1.0 Introduction

G-IV s/n 1225, N450KK is currently operated by La Venezolana de Seguros y Vida CA.

G-IV S/N 1225 Structural Evaluation-Over Pressurization Event

Fig. 7-6

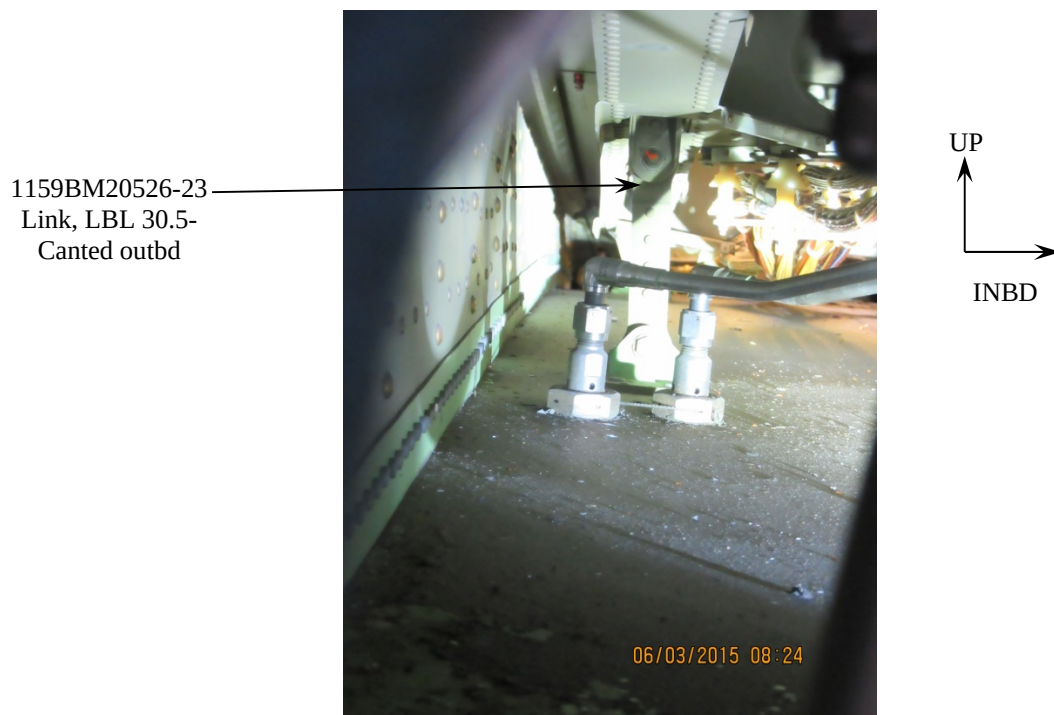
- iii. FS 412.00:
 - a. LBL 30.5 The link was attached at the upper and lower points. The upper attachment was leaning outboard (Fig. 7.6).
 - b. LBL 18 The link was attached at the upper and lower points. The upper attachment was leaning outboard (Fig. 7-5).

- i. At each identified link location, remove and replace the noted link(s) and install with new hardware in accordance with Chapter 53-30-00 of the G-IV Illustrated Parts Catalog (IPC):
- ii. Prior to installation of the new links, High frequency Eddy Current (HFEC) Inspect the associated attach fittings on the wings for cracks in accordance with the G-IV Non-Destructive Testing (NDT) Manual. Pay particular attention to the lugs, holes and the fillet radii of the vertical legs.
- iii. Inspect the hole diameters of the associated attach fittings on the wings (Ref. Fig. 7-10):

Fig. 7-7

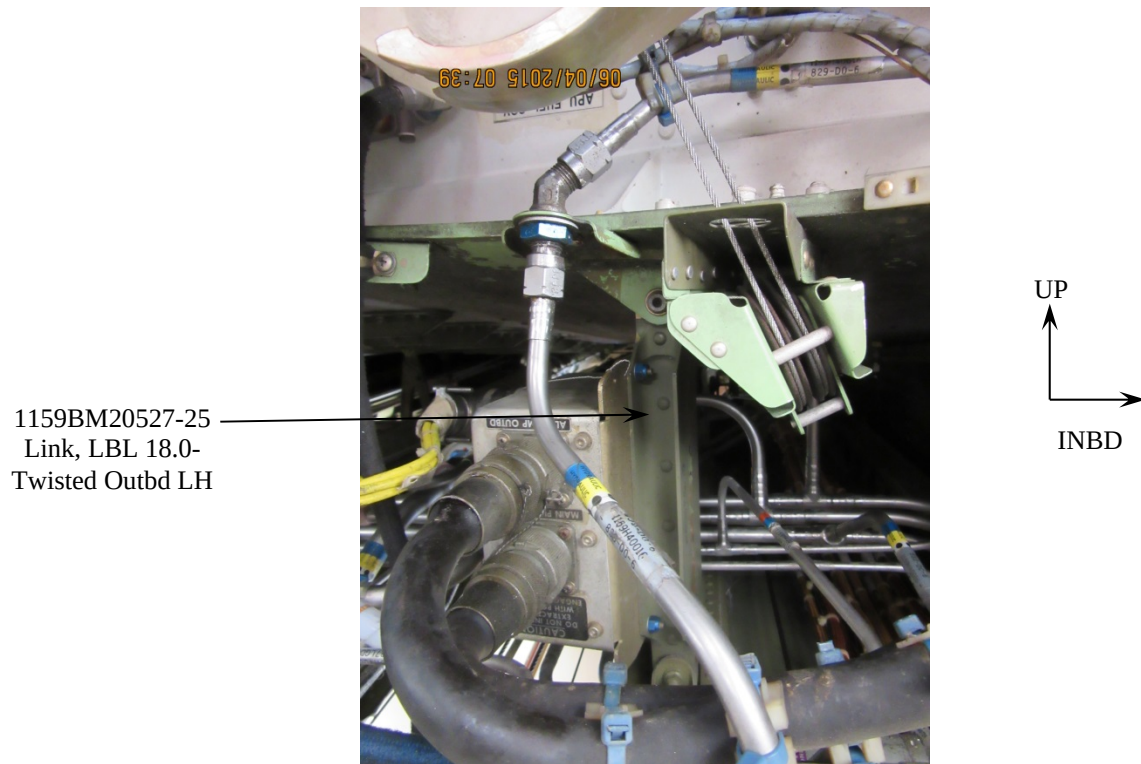
- a. LBL 30.5 No link at this location.
 - b. LBL 18 The link was vertical, but visibly twisted to the left when looking forward (Fig. 7-7).
 - c. LBL 6 The link was vertical, but visibly twisted to the left when looking forward (Fig. 7-8).

Fig. 7-9

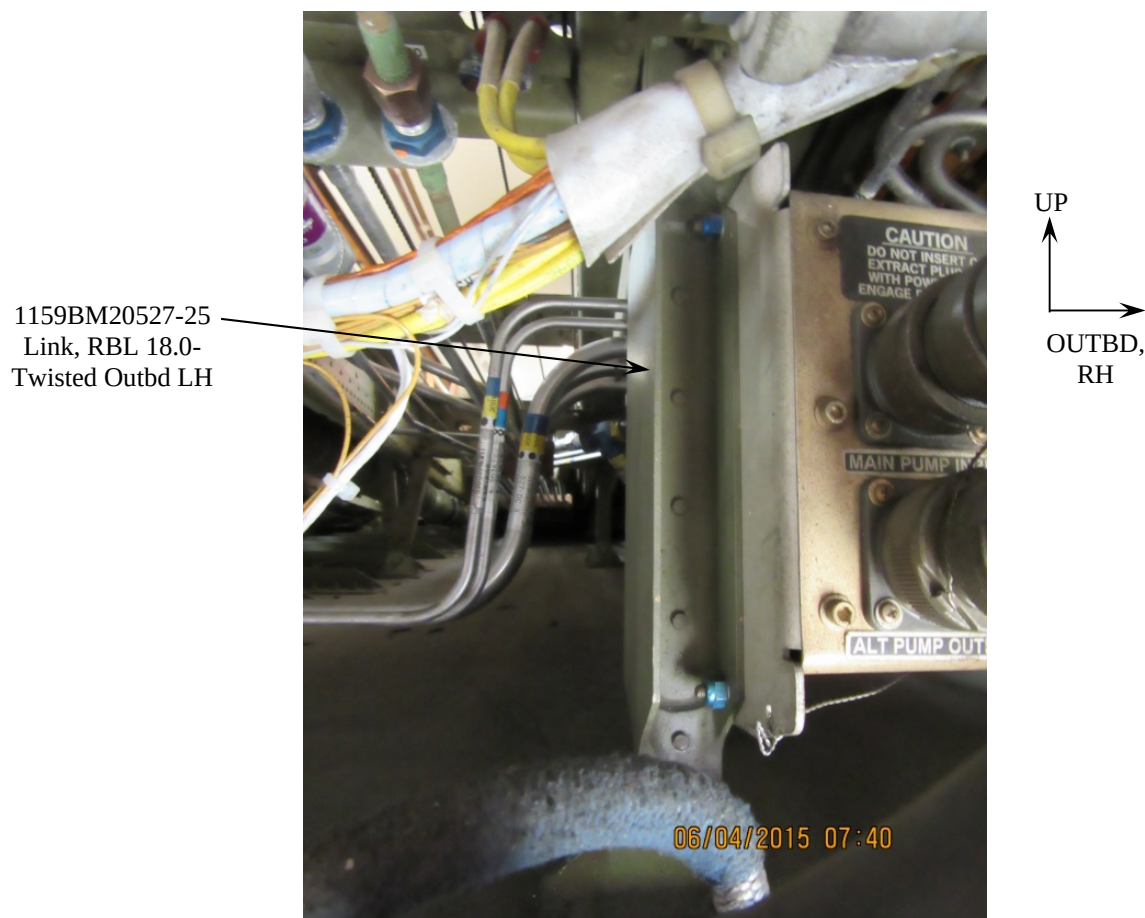
- d. RBL 6 The link appeared to be vertical and installed properly.
 - e. RBL 18 The link was vertical, but visibly twisted to the left when looking forward (Fig. 7-9).
